**Ipswich City Council**

Re: MEDQ Delegate Further Information Request
Application No: 3406/2025/PDA
Proposal:
- Context Plan (to supersede Context Plan subject of 10397/2023/MAPDA)
- Reconfiguring a Lot – One (1) Lot into Three Hundred and Ten (310) Lots {consisting of 301 Residential lots, One (1) Future Multiple Residential Lot, One (1) Balance Lot, Four (4) Drainage Reserve/Stormwater Management Lots, One (1) Neighbourhood Recreation Park lot, One (1) District Recreation Park Lot, One (1) Open Space (Conservation Area) lot}; and
- Associated Plan of Development (POD) for a House {over Three Hundred and One (301) Residential Lots}; and Display Village, Temporary Sales Office and related Advertising Devices

Property Location: 817-843 Ripley Road, SOUTH RIPLEY QLD 4306

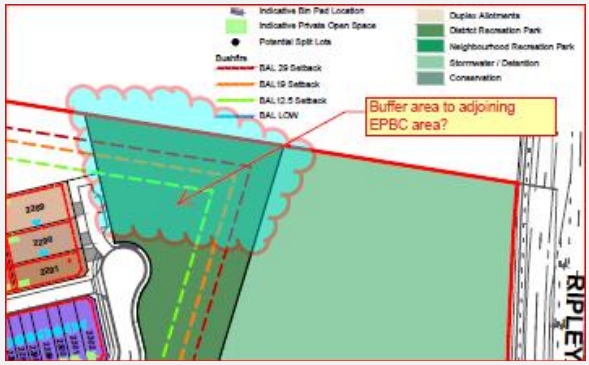
*(vii) Dedicated legible shared pathway connection from the 4m emergency access pathway (connection to Ripley Road) to Road 1 and Catalyst Road is required for connecting both internal and wider community.*

*(viii) Provide details of all the stair locations that inhibit direct accessible access to facilities. (all facilities require accessible access from both road footpath and car park areas)*

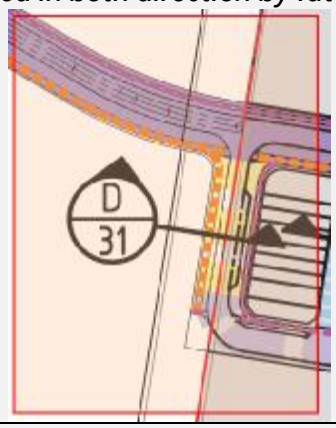
(i) Provide bus parking to the District Recreation Park. It is noted that the proposed location on catalyst road is not an appropriate solution to service the park.

(ii) As a result of addressing (i), ensure that the roads are capable of accommodating Coach bus manoeuvring and parking on-street.
*Note: 2 potential routes are outlined below, however may be affected by topography. Compliant DDA access required from bus park to park facilities must be demonstrated.*

*Note: this will likely remove some proposed on-street car parks.*

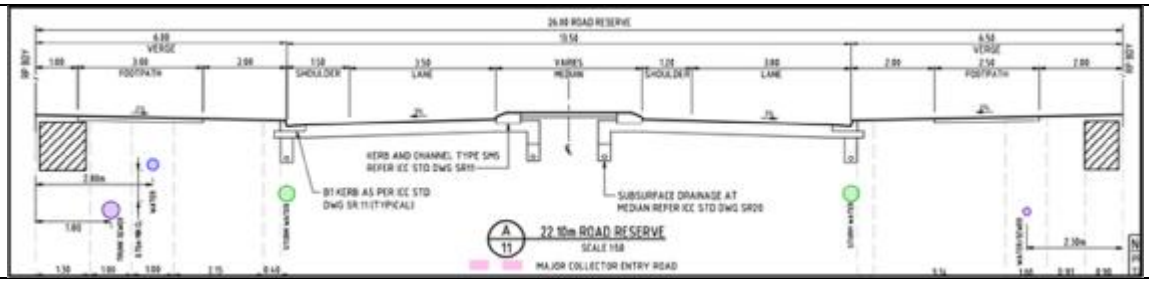
| (b) | Road 01 (Neighbourhood Connection connecting to South West Trunk Road) includes a 5.0m centre median and 5.0m carriageway either side of the median, which is supported, however it is unclear why Road Section A in the KN Group Civil Functional Plans has a 1.5m shoulder adjacent to the outer kerb in one direction, and a 1.2m wide shoulder adjacent to the median kerb in the other direction (refer image below). The applicant is requested to amend the cross section nominating 1.5m shoulder adjacent to the outer kerb for both directions of travel. |

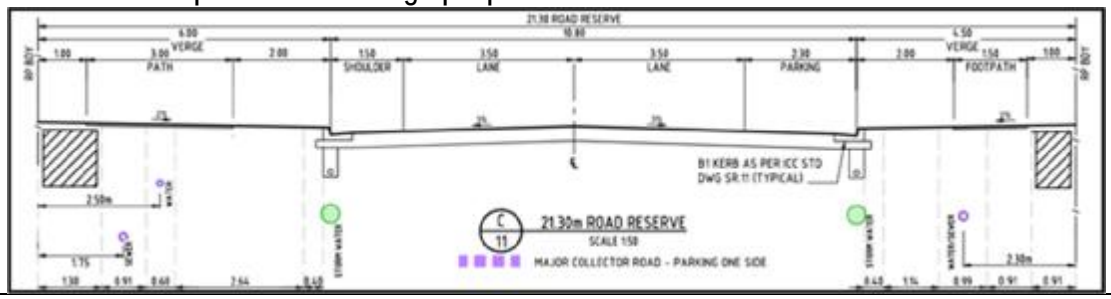
(c) Road 02 (East West Neighbourhood Connector) proposes parking on both sides to the west of Road 07 (Section B in the KN Group Functional Plans), which is supported, however it is unclear as to why the parking lane on the southern side falls towards the main carriageway with a v drain. The ROL and civil drawings nominate barrier kerbs only at the interface of carriageway and verge. Therefore, the applicant is requested to amend the cross section as both parking lanes shall have standard cross fall and drain towards the verge, unless there is technical justification to adopt a nonstandard outcome.

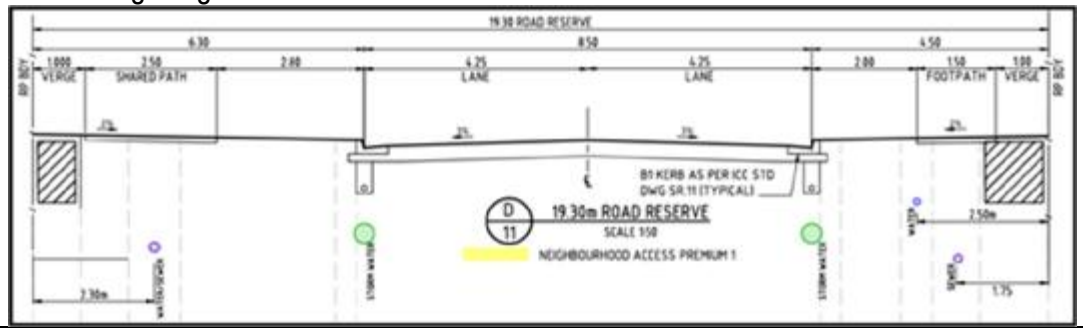
(d) Road 02 (East West Neighbourhood Connector) proposes parking on one side only, between Road 01 and Road 07 (Section C in the KN Group Civil Functional Plans), but includes a 1.5m wide shoulder on the side without parking. The applicant is requested to review if the 1.5m shoulder is required for drainage purposes or if it could be reduced or removed.

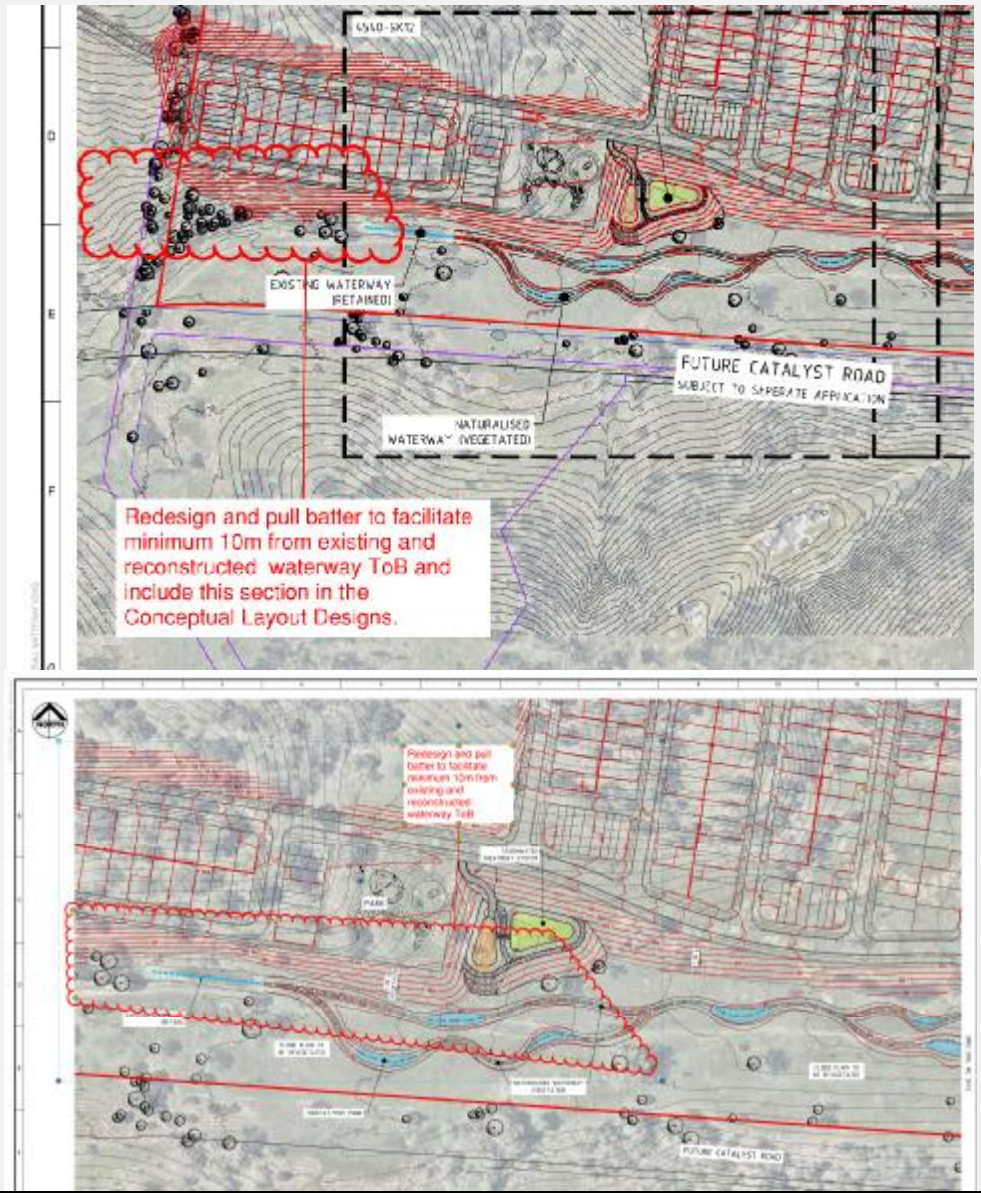
| 15. | Waterway |
|---|---|
| *(b)* | *The applicant is requested to submit an amended Concept Functional Waterway Design and reporting inclusive of green infrastructure, complex fauna habitat features and facilitate a largely fully vegetation outcome consistent with the mapped regional ecosystems for the site and vegetated riparian corridor intent. To demonstrate this, the applicant is requested to address item (e) below, the other items of this information request relating to the waterway design and provide an assessment and appropriately scaled plans showing post development expected velocities, bed shear and shear stress, identify the areas/ extent of rock protection, location of complex habitat (terrestrial and aquatic) features. The design should be responsive* |
| | *to the local environment soil conditions and existing vegetation.* |

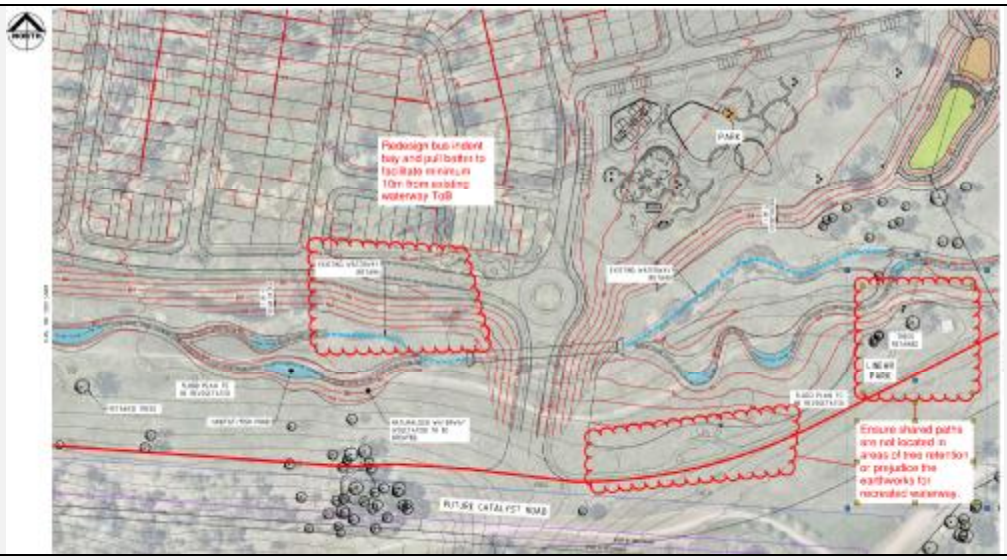
| 15. | Waterway |
|---|---|
| *(e)* | *The applicant is requested to redesign the waterway functional layout to address retention of vegetation proximate to the earthworks interface as per Item 14 – Vegetation Retention, remove indicative proposed pathways and earthworks that impact on vegetation or constrain the waterway (locate them on the periphery adjacent to roads), locate the emergency access to avoid impacts to the ephemeral sedge and reduce extent of culvert length in accordance with Item 7 – Traffic Impact Assessment. The images below identify key areas of council concern for the waterway impingement.*   |
